WOODEN CANOE AT WATERDANCE
DESIGN REVIEW COMMITTEE

Re: Wooden Canoe, Lot 54 – 549 Water Dance Drive

**RE: 549 Water Dance Drive, Lot 55
Hot Tub Installation**

IMPROVEMENT LOCATION CERTIFICATE

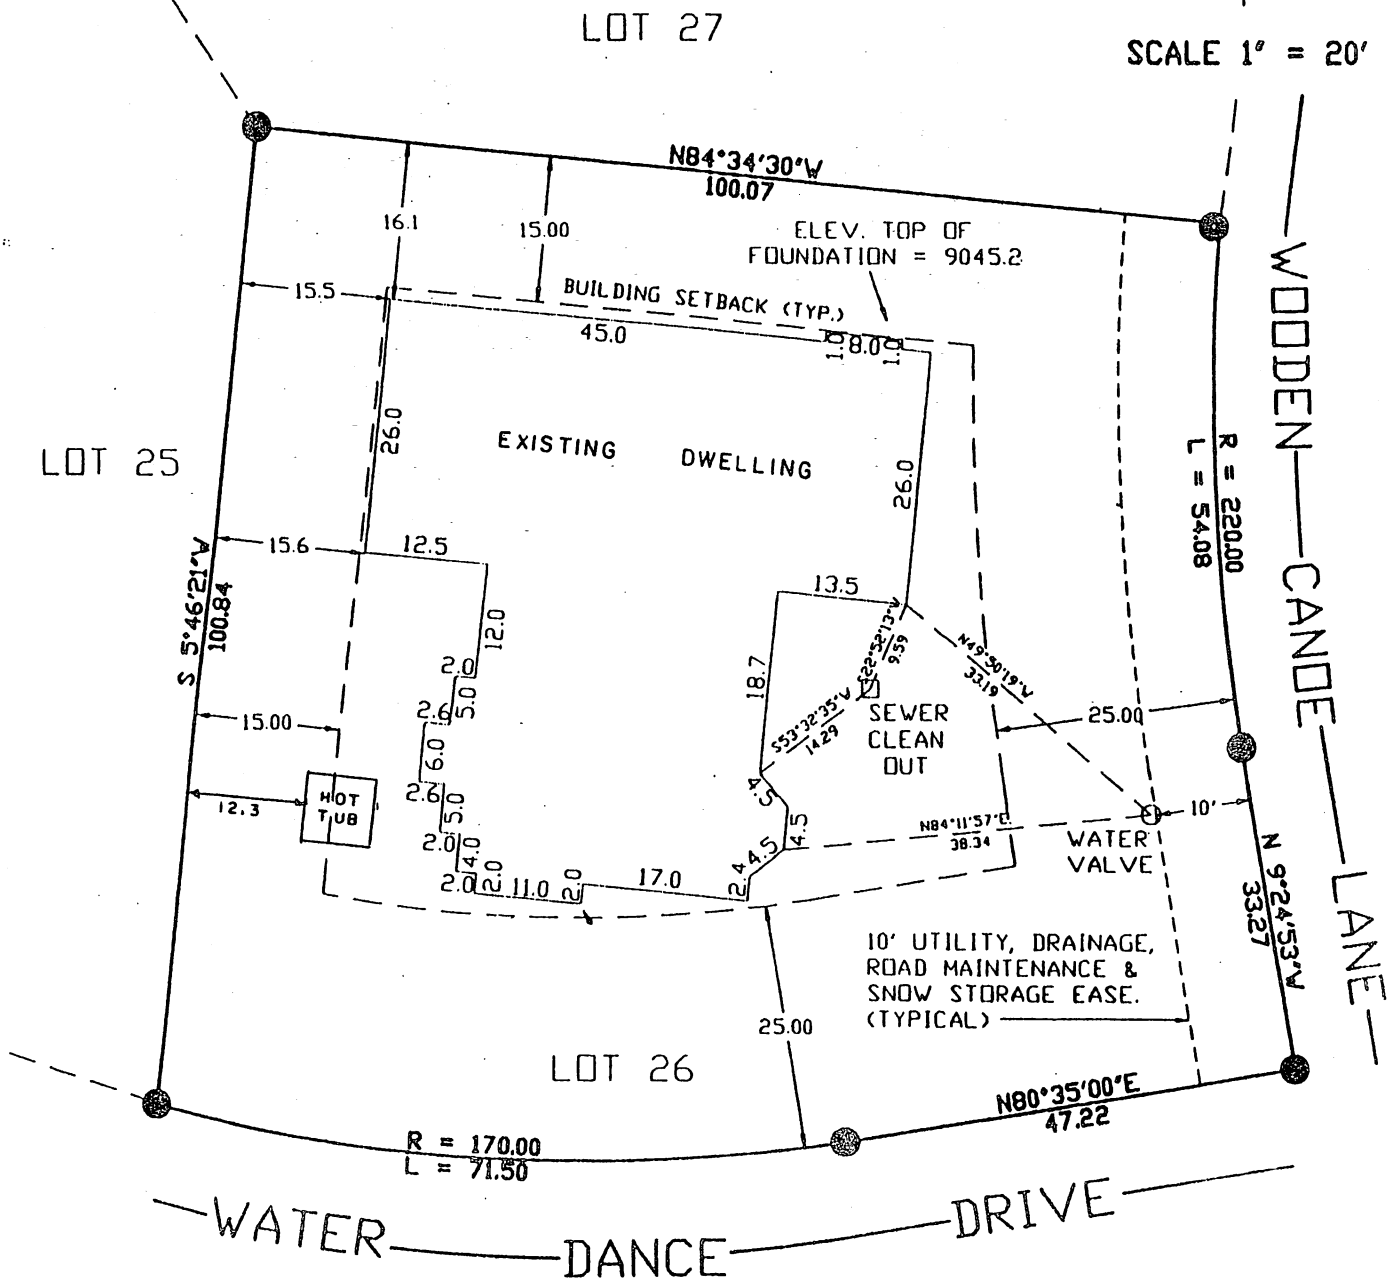
Concern has been raised amongst the homeowners of Water Dance as well as the Design Review Board that the hot tub location as constructed on Lot 26 is encroaching beyond the building envelope. As was mentioned in the meeting, if this encroachment is less than 2 feet we ask you to submit plans to screen the hot tub for our review at our next Design Review Board meeting. If the hot tub location is determined to be beyond 2 feet, as is shown on a licensed surveyor's drawing, then the Design Review Board will require that the hot tub be relocated within the building envelope.

We will review this issue further once we have seen the survey of the current hot tub's locations
